UPPER UWCHLAN TOWNSHIP
PLANNING COMMISSION
AGENDA
April 13, 2023

April 7, 2023

Reference: 301 Park Road – P.J. Reilly Contracting, Inc.
Proposed Headquarters Building
Preliminary Land Development Application – 2nd Review
Upper Uwchlan Township, Chester County, PA

PLAN TITLE:
PRELIMINARY LAND DEVELOPMENT PLAN
SITE LAYOUT PLAN

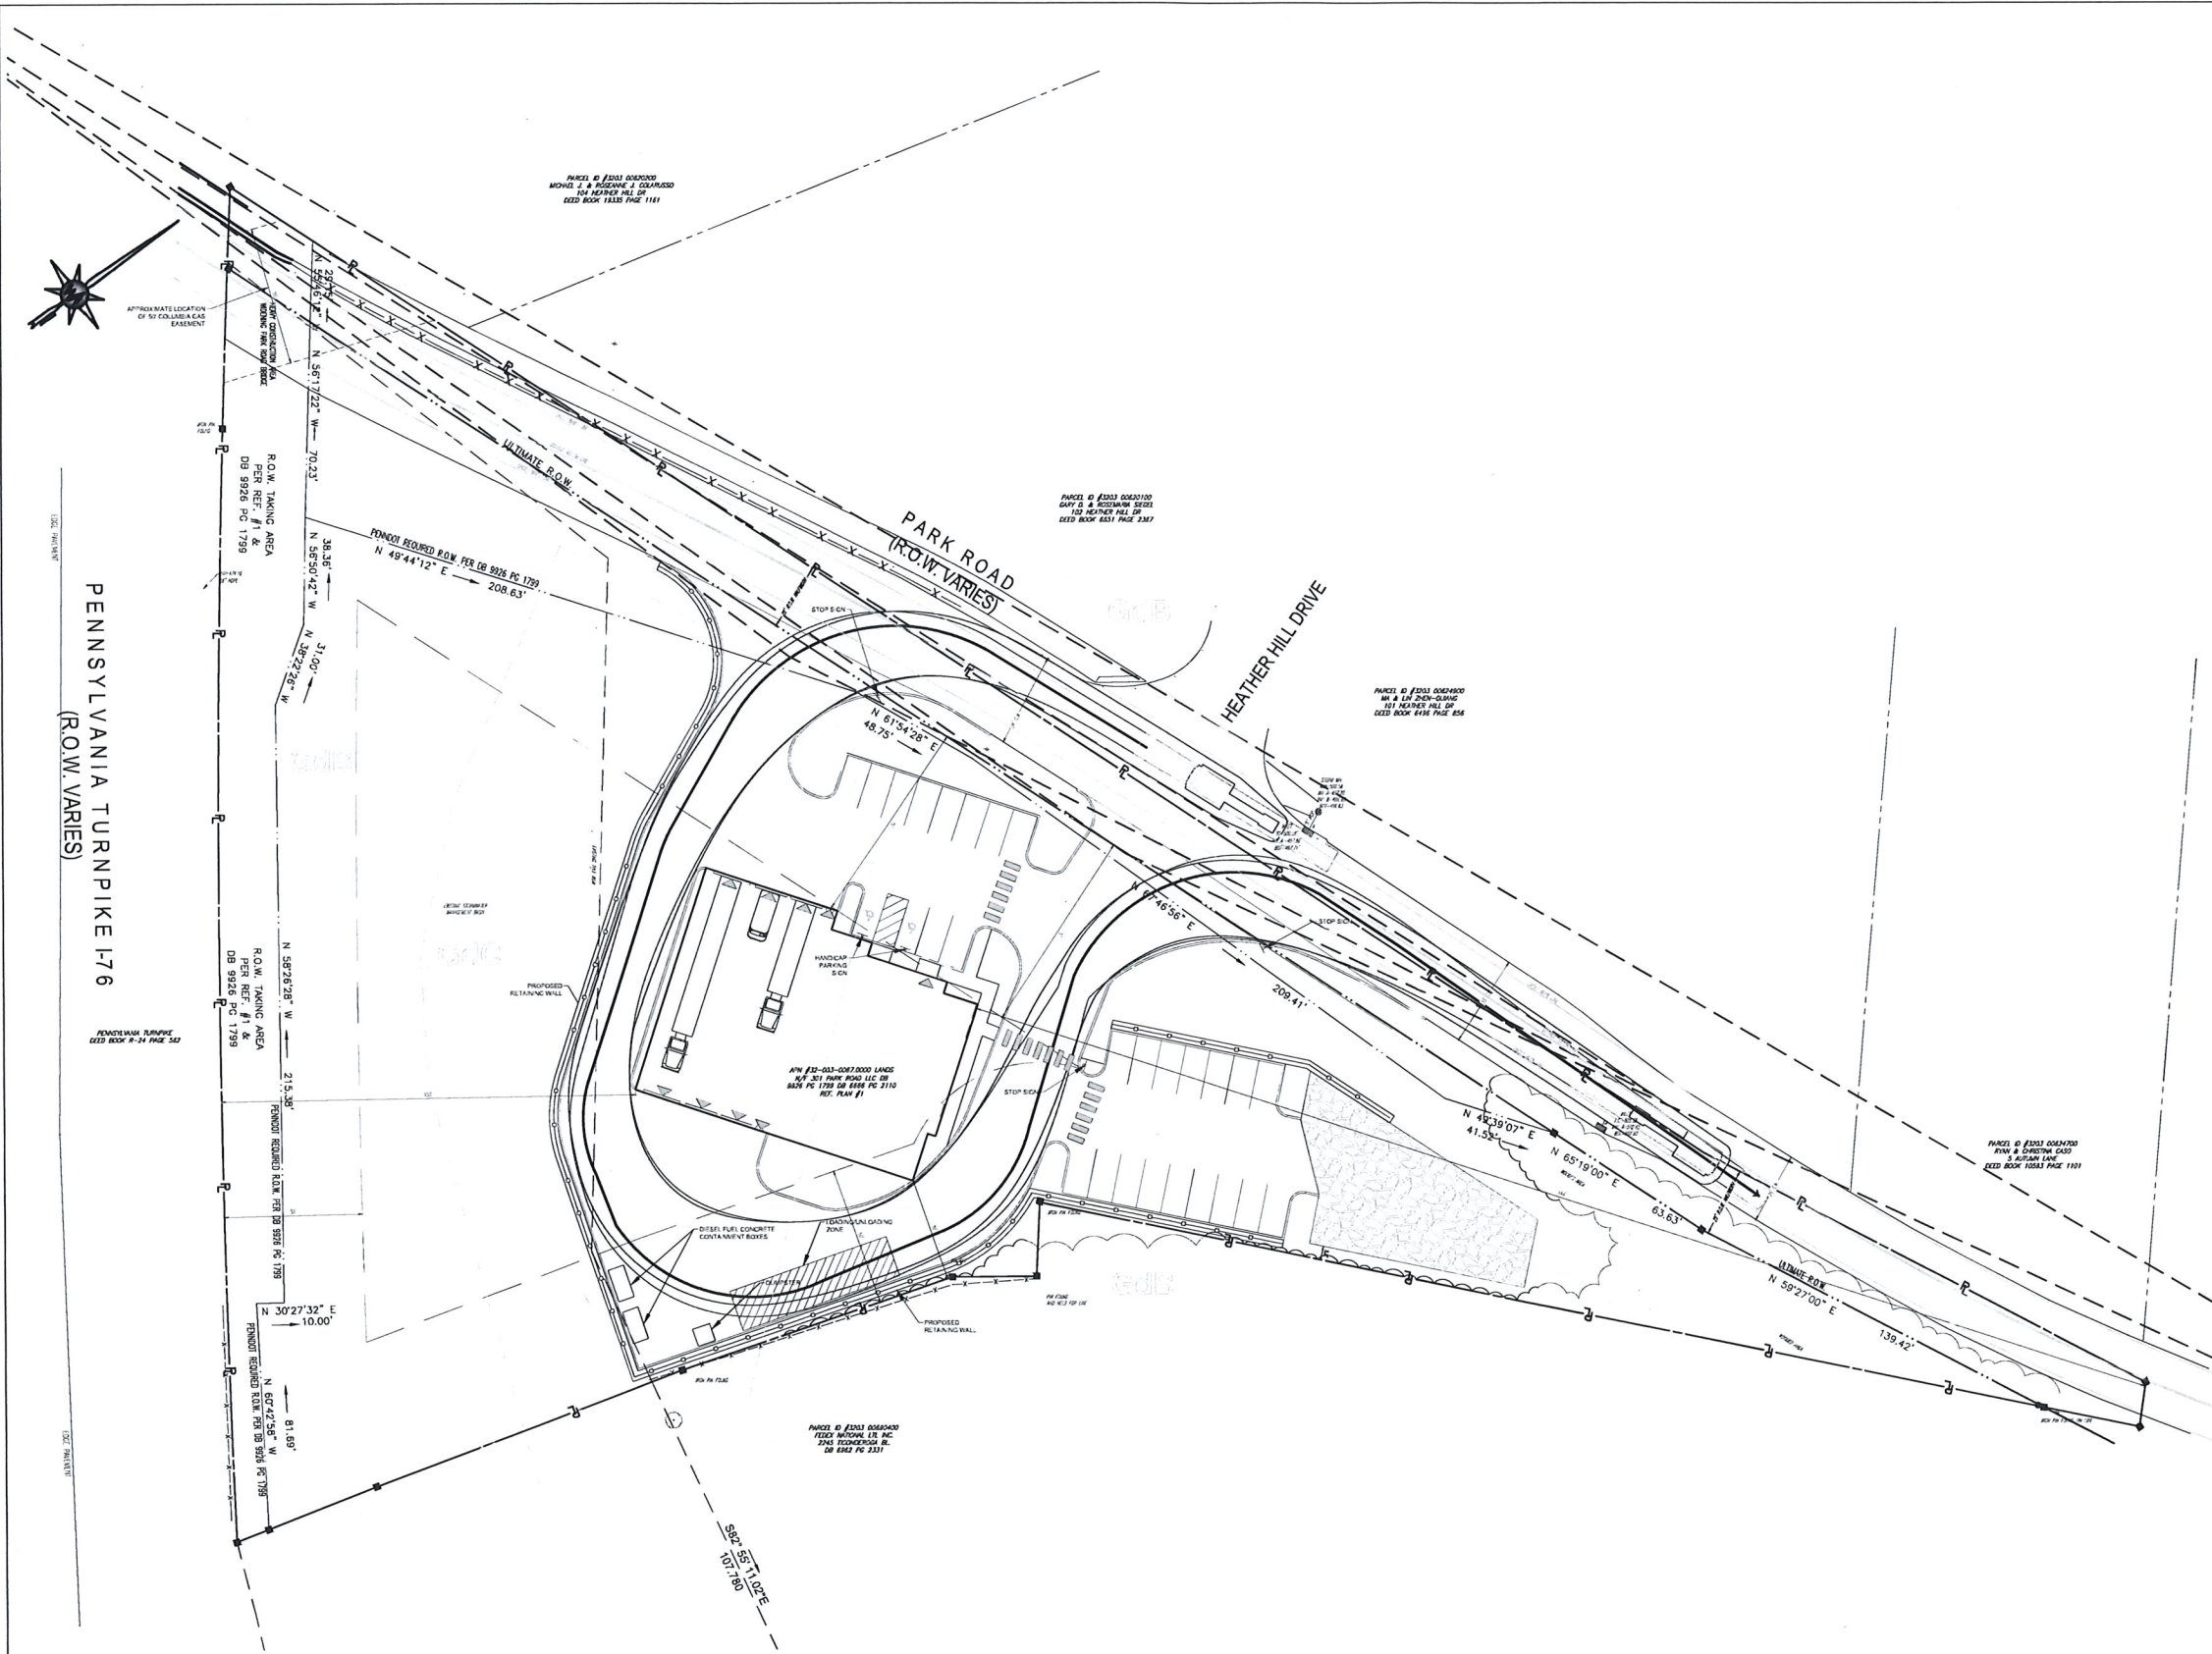
2. (V) *Section 200-45 – A portion of the proposed building is shown within the required rear yard setback, which will require a variance. The Applicant has noted on Sheet 4 they will be seeking this relief.*
3. *Section 200-45.F – Add the accessory buildings/structures restriction to the Zoning table on Sheet 4: No accessory building or structure shall be located within the front yard, nor within 30 feet of any side or rear lot line. The plans show the Diesel Fuel Concrete Containment Boxes within 30 feet of the rear yard. These should be relocated to comply with this section.*
4. (V) *Section 200-73.A(3) – In any industrial district, no parking, loading or service area shall be located within 25 feet of the ultimate right-of-way line. **Show the ultimate right-of-way of Park Road as well as this setback.***

The Applicant has noted on Sheet 4 that they will be seeking a variance from this requirement.

The plans show two (2) “Diesel Fuel Concrete Containment Boxes.” Sheet 4 notes “No fuel or other explosive materials will be stored on site.” Clarify the purpose of the Diesel Fuel Concrete Containment Boxes.

Temporary construction easements are now shown on Sheets 16 and 17. **Executed easement agreements shall be provided to the Township prior to Final Plan Approval. In addition, these easements should be delineated on the "Site Layout Plan".**

6. ZO Section 200-73.H The parking tabulation on sheet 4 indicates that the proposed 3,900 square feet of office space will require 15 parking spaces. However, since the Township’s parking supply requirement for office space is five parking spaces per 1,000 square feet, the parking requirement for the office space would be 20 parking spaces ($3.9 \times 5 = 20$ parking spaces), and as such, additional parking spaces will be required. In addition, the applicant’s response to comment 1 indicates the office square-footage will be 4,000 square feet, and the parking tabulation should be updated to show the total square-footage of the office space.

DESIGNED VRS	PROJECT # 2021-231
CHECKED (PM) VRS	DRAWING # 5 OF 19
DATE 11/01/2022	
SCALE AS SHOWN

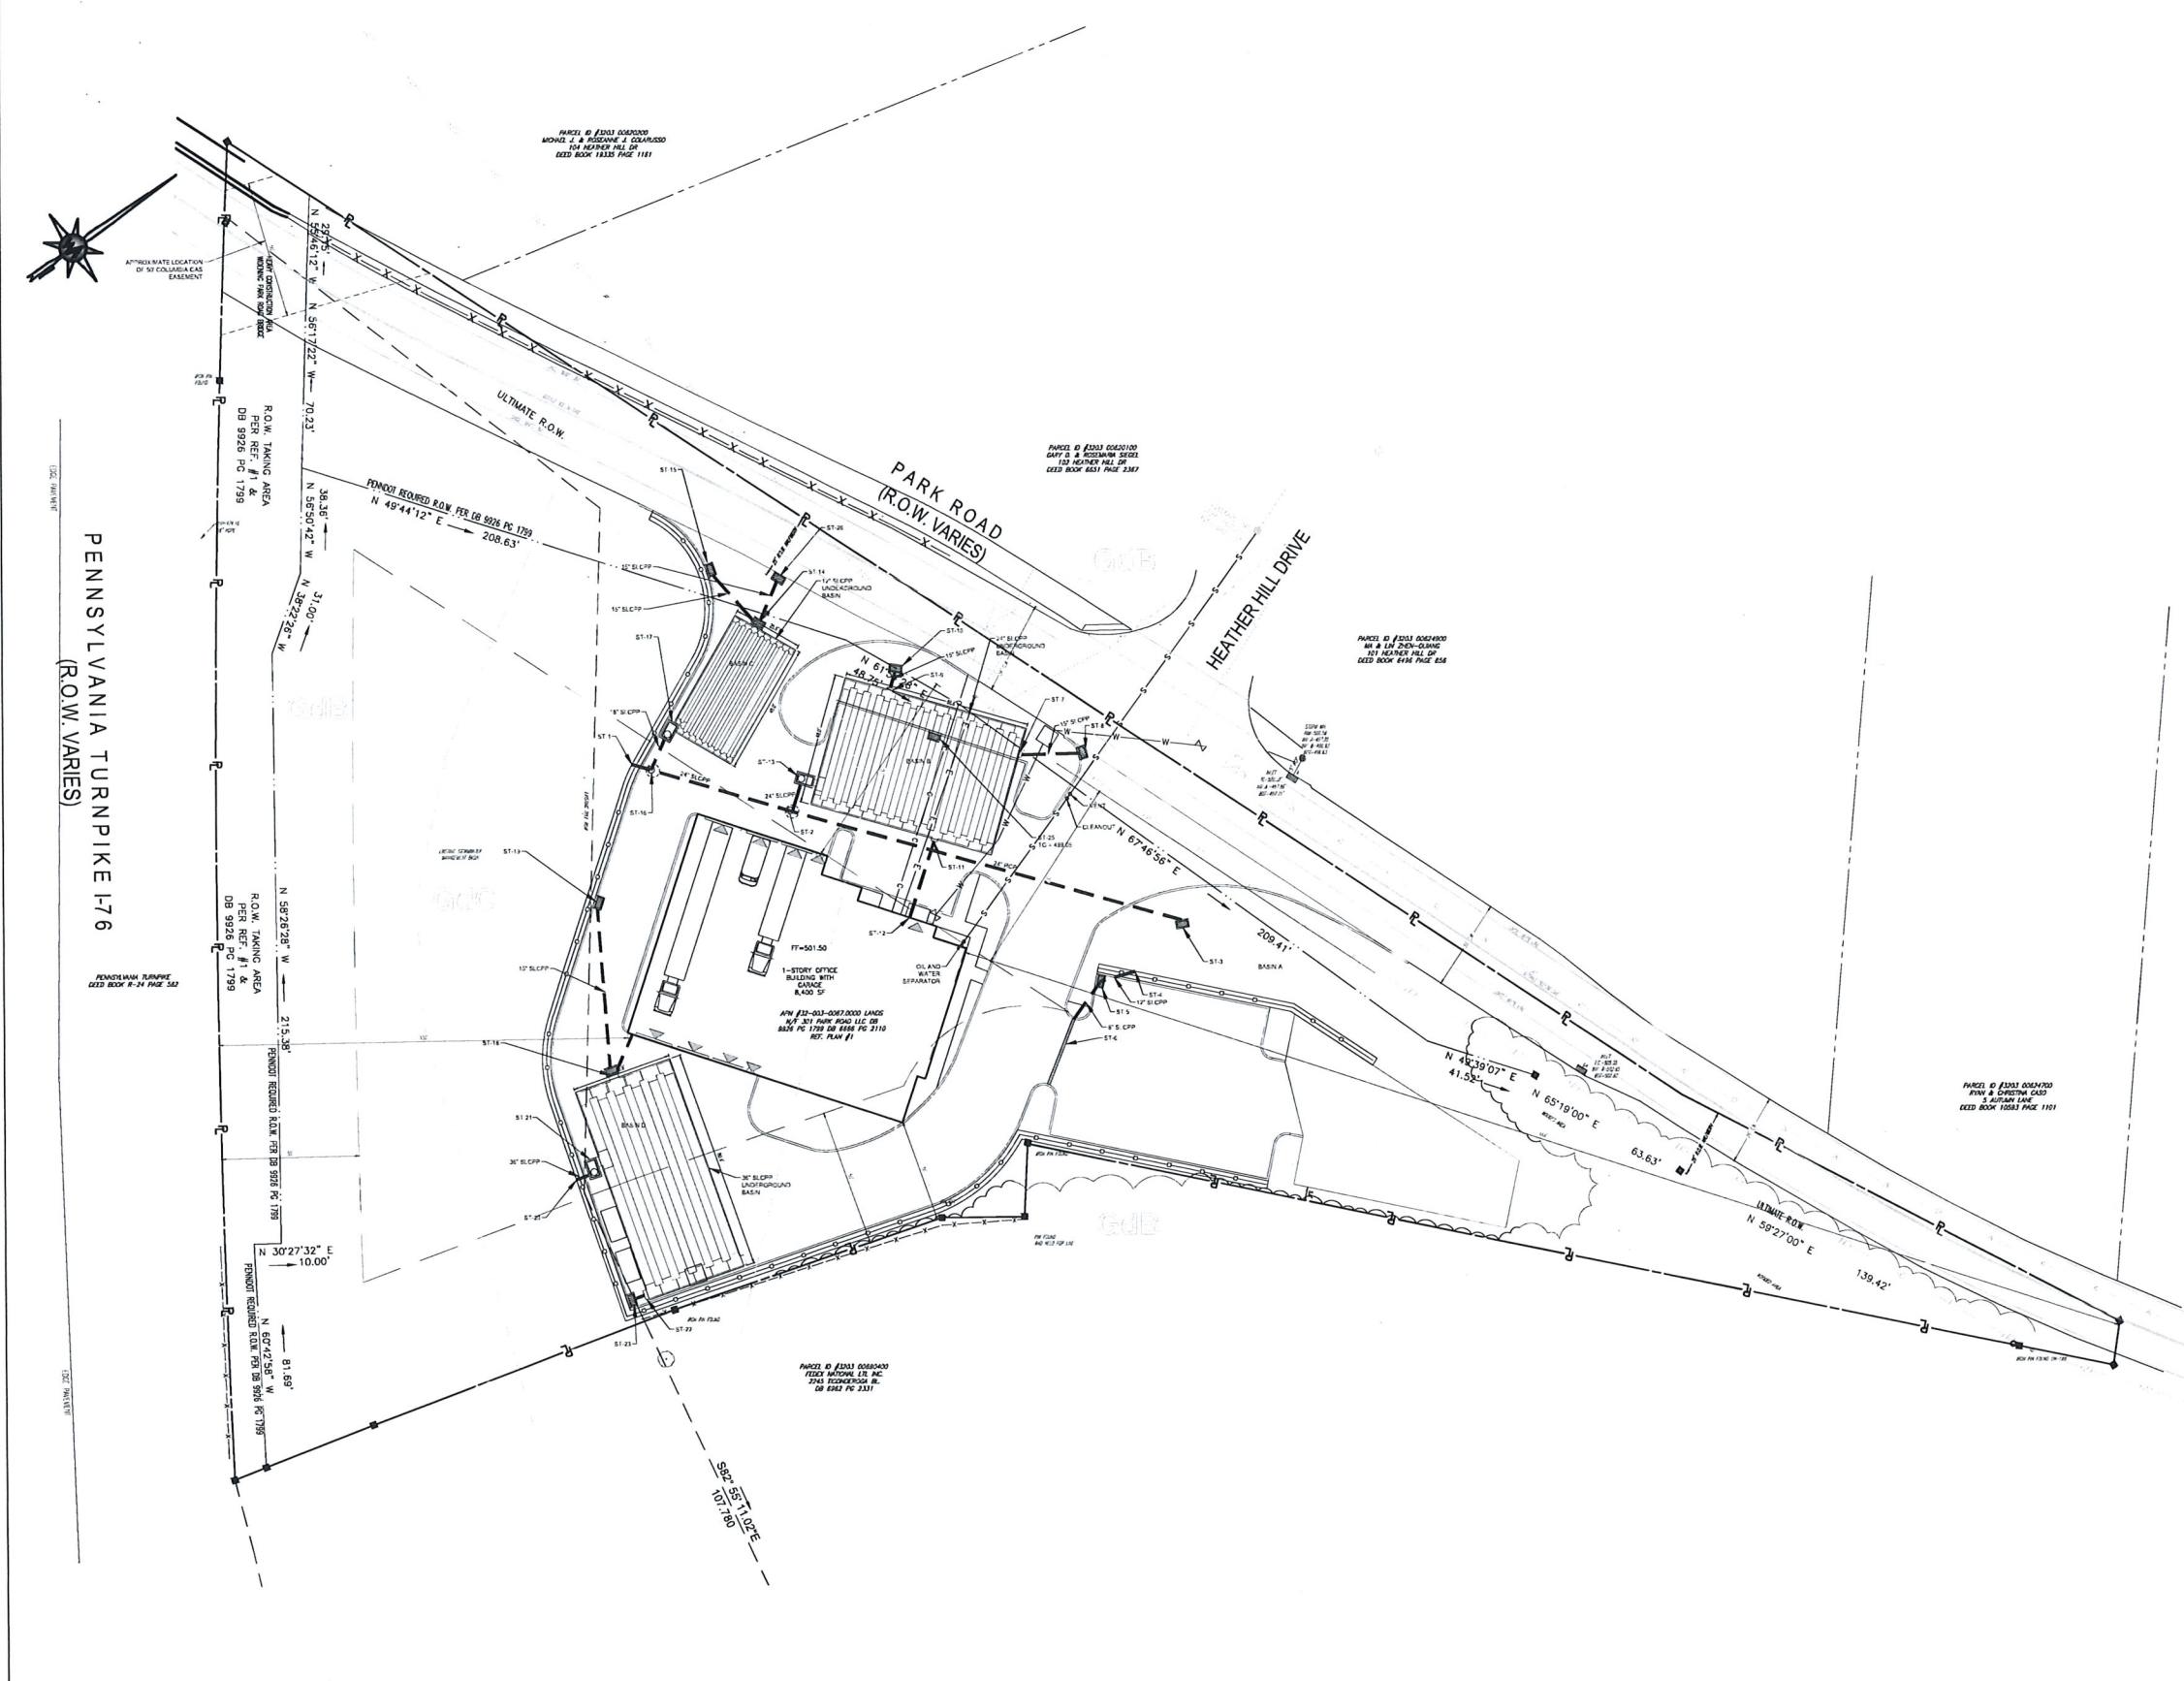
3. Section 162-27.1.K(1) – The following comments related to the truck turning template plan (sheet 5):
 - a. Provide the dimensions of the largest truck expected to access the site.

- b. As previously requested, truck turning templates for the Township's largest emergency service vehicle should also be provided.
 - c. As currently shown, the on-site circulation of the truck will traverse in close proximity to the proposed building. If feasible, the applicant's engineer should modify the internal site layout to provide additional space for the trucks to navigate within the site in the vicinity of the building.

- e. The truck templates do not show any trucks entering or exiting to/from the west along Park Road. Please confirm the proposed truck routes, and a note to the plan to memorialize the proposed truck routes.
